Submission to

Casey Fields South Employment & Devon Meadows PSP, DSS & Amendment C295 case

90 Clyde – Five Ways Road, 70 & 130 Moores Road, Clyde

Issued
31 March 2025

Figure 1: Extract from PSP Plan 2: Place Based Plan (VPA 2025)

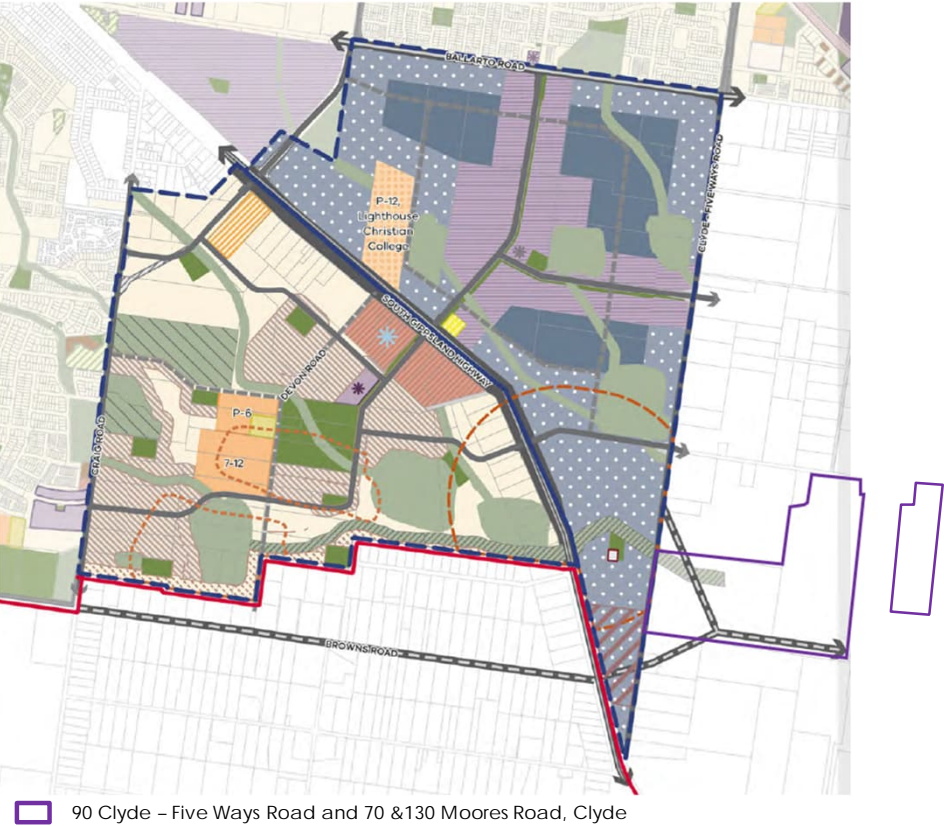
Our client makes this submission because whilst the subject land is located within a neighbouring PSP, the CFS&DM PSP and DSS propose land use outcomes that will directly impact the existing land uses and potential development opportunities in the future. Specifically, these documents propose to apply the Public Acquisition Overlay Schedule 4 (PAO4) to the subject land to facilitate the purchase and construction of a diversion waterway to an existing drainage channel that runs through the site. The CFS&DM PSP also illustrates an inductive future road network across the subject land despite the land not forming part of the CFS&DM PSP.

Based on a review of the CFS&DM PSP, DSS and Amendment documentation, our client strongly objects to the draft CFS&DM PSP and the CFS&DM DSS as it applies to Clyde South and the subject land.

Figure 10: Proposed PAO4 (Source: Exhibited Amendment C295case)

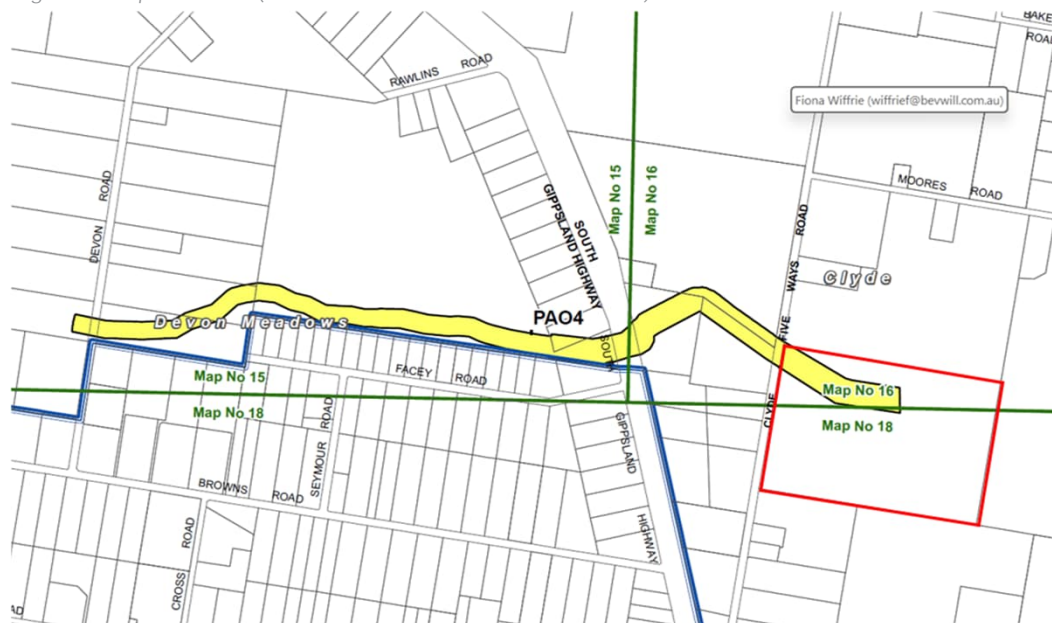
The CFS&DM PSP and DSS propose a 40m wide Public Acquisition Overlay over 90 Clyde – Five Ways Road to facilitate drainage for the entire Devon Meadows Precinct and to improve what Melbourne Water has described as 'legacy issues' associated with the Devon Meadows rural residencies located beyond the Urban Growth Boundary. The total land-take associated with proposed PAO4 as it applies to 90 Clyde – Five Ways is approximately 2ha.

Preliminary investigations have identified that parts of the Public Acquisition Overlay (PAO) are located on a rise in the westernmost section of the Devon Meadows precinct which will require significant earthworks to construct the future waterway. At its widest point, the waterway could be in the order of 100m wide to allow for appropriate batters. A more detailed analysis also indicates that the diversion channel, when compared with GHD's groundwater observations, significant sections of the channel appear to be below the groundwater level which will likely contribute to further increases in flows into Clyde South.

It is submitted that the application of the PAO is premature and requires further investigations to confirm the accurate extent of land required to facilitate the current drainage scheme proposal.

Until this work has been undertaken, Villawood strongly objects to the application of PAO-4 and the diversion waterway across their site.

Figure 11: Preliminary Concept Drainage Strategy Plan (Source: Draft CFS&DM DSS - GHD 2024)

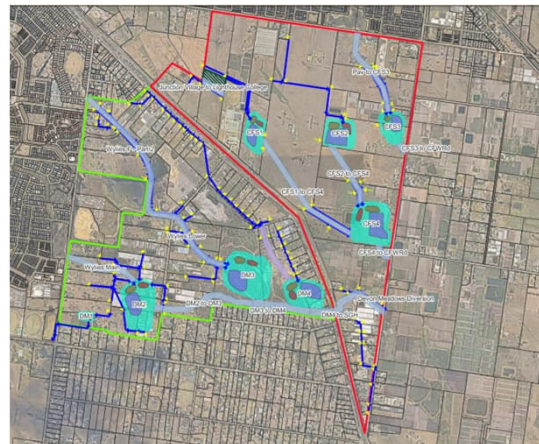
The stated purpose of this channel was to protect downstream homes in Devon Meadows from flooding and excessive increases in volumetric discharge. While redirecting flows from Devon Meadows would protect these homes from the issues above, its not clear how it solves the issue. Rather it just relocates it as a problem for the landowners on Clyde South to manage until such time as they PSP/DSS can be developed and implemented. Even then, the issue will require additional assets or negotiation with downstream owners to resolve.

- Preliminary analysis indicates that the diversion channel requires significant cut to achieve the required levels, particularly between basins DM2 and DM3.

- At its deepest, up to 10m of cut will be required which with the proposed 1:5 batters could require a reserve width of up to 100m at its widest rather than the 40m proposed by the PAO. This would require a significant volume of earthworks to achieve which will incur significant cost.

- When compared with GHD's groundwater observations, it appears that significant sections of the channel are proposed to be below the groundwater level which raises several key issues:

In summary, the proposed channel appears to be a drastic and expensive measure directed at solving a problem that was not properly assessed/quantified. It does not appear even resolve the perceived issue, instead just relocating it to a different location. It is strongly recommended that the diversion channel as proposed is abandoned and focus is placed on an alternate solution to protect homes in Devon Meadows.

At this time, the proposed strategy relies on 3 connection points (shown in images below). These points are characterised by:

- Roads being only marginally above the surrounding floodplain.
- An absence of any major drainage features, which are at best a small drainage channel and culvert and at worst no drainage feature at all.

- Removal of the diversion drain to be replaced with minor improvements to the existing channels downstream and including of a 225mm diversion drain for re-use.
- Redesign of the Devon Meadows basins to demonstrate that objectives can be met without the need to divert to Clyde South.
- Concept design of works downstream of Clyde Five Ways Rd to allow MW and the VPA to arrange a PAO to secure outfalls for Casey Fields.
- Additional concept design of a potential diversion drain around Lighthouse College.
- An examination of Casey Fields basins to determine if there is a more efficient/equitable distribution of assets.

Figure 12: Extract from PSP Plan 4: Movement Network (VPA 2025)

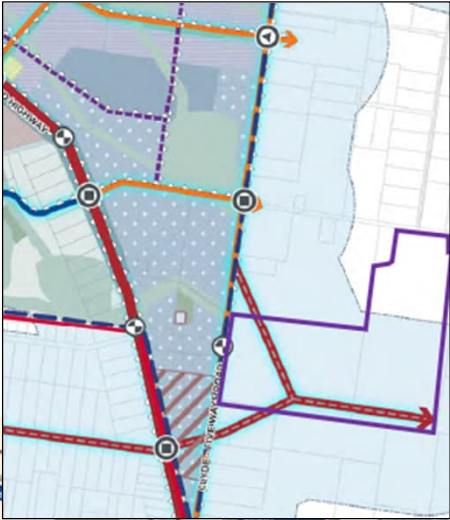
CFS&DM PSP Plan 4 – Movement Network identifies 2 indicative 4-lane secondary arterial roads traversing 90 Clyde – Five Ways and 70 Moores Road at various angles (Figure 11).

A review of the Strategic Traffic Modelling Report (which incorporates Clyde South) has been prepared to inform the proposed future road network for the CFS&DM PSP. Notably, the report does not provide commentary or imagery to support the indicative secondary arterial road as proposed on the subject land, as illustrated Figure 12. It is submitted that the nomination of a future road network within the Clyde South PSP is more appropriately addressed through the Clyde South PSP.

It is submitted that the proposed road network as it applies to 90 Clyde – Five Ways and 70 Moores Road, must be removed from all plans within the CFS&DM PSP as it is not justified.
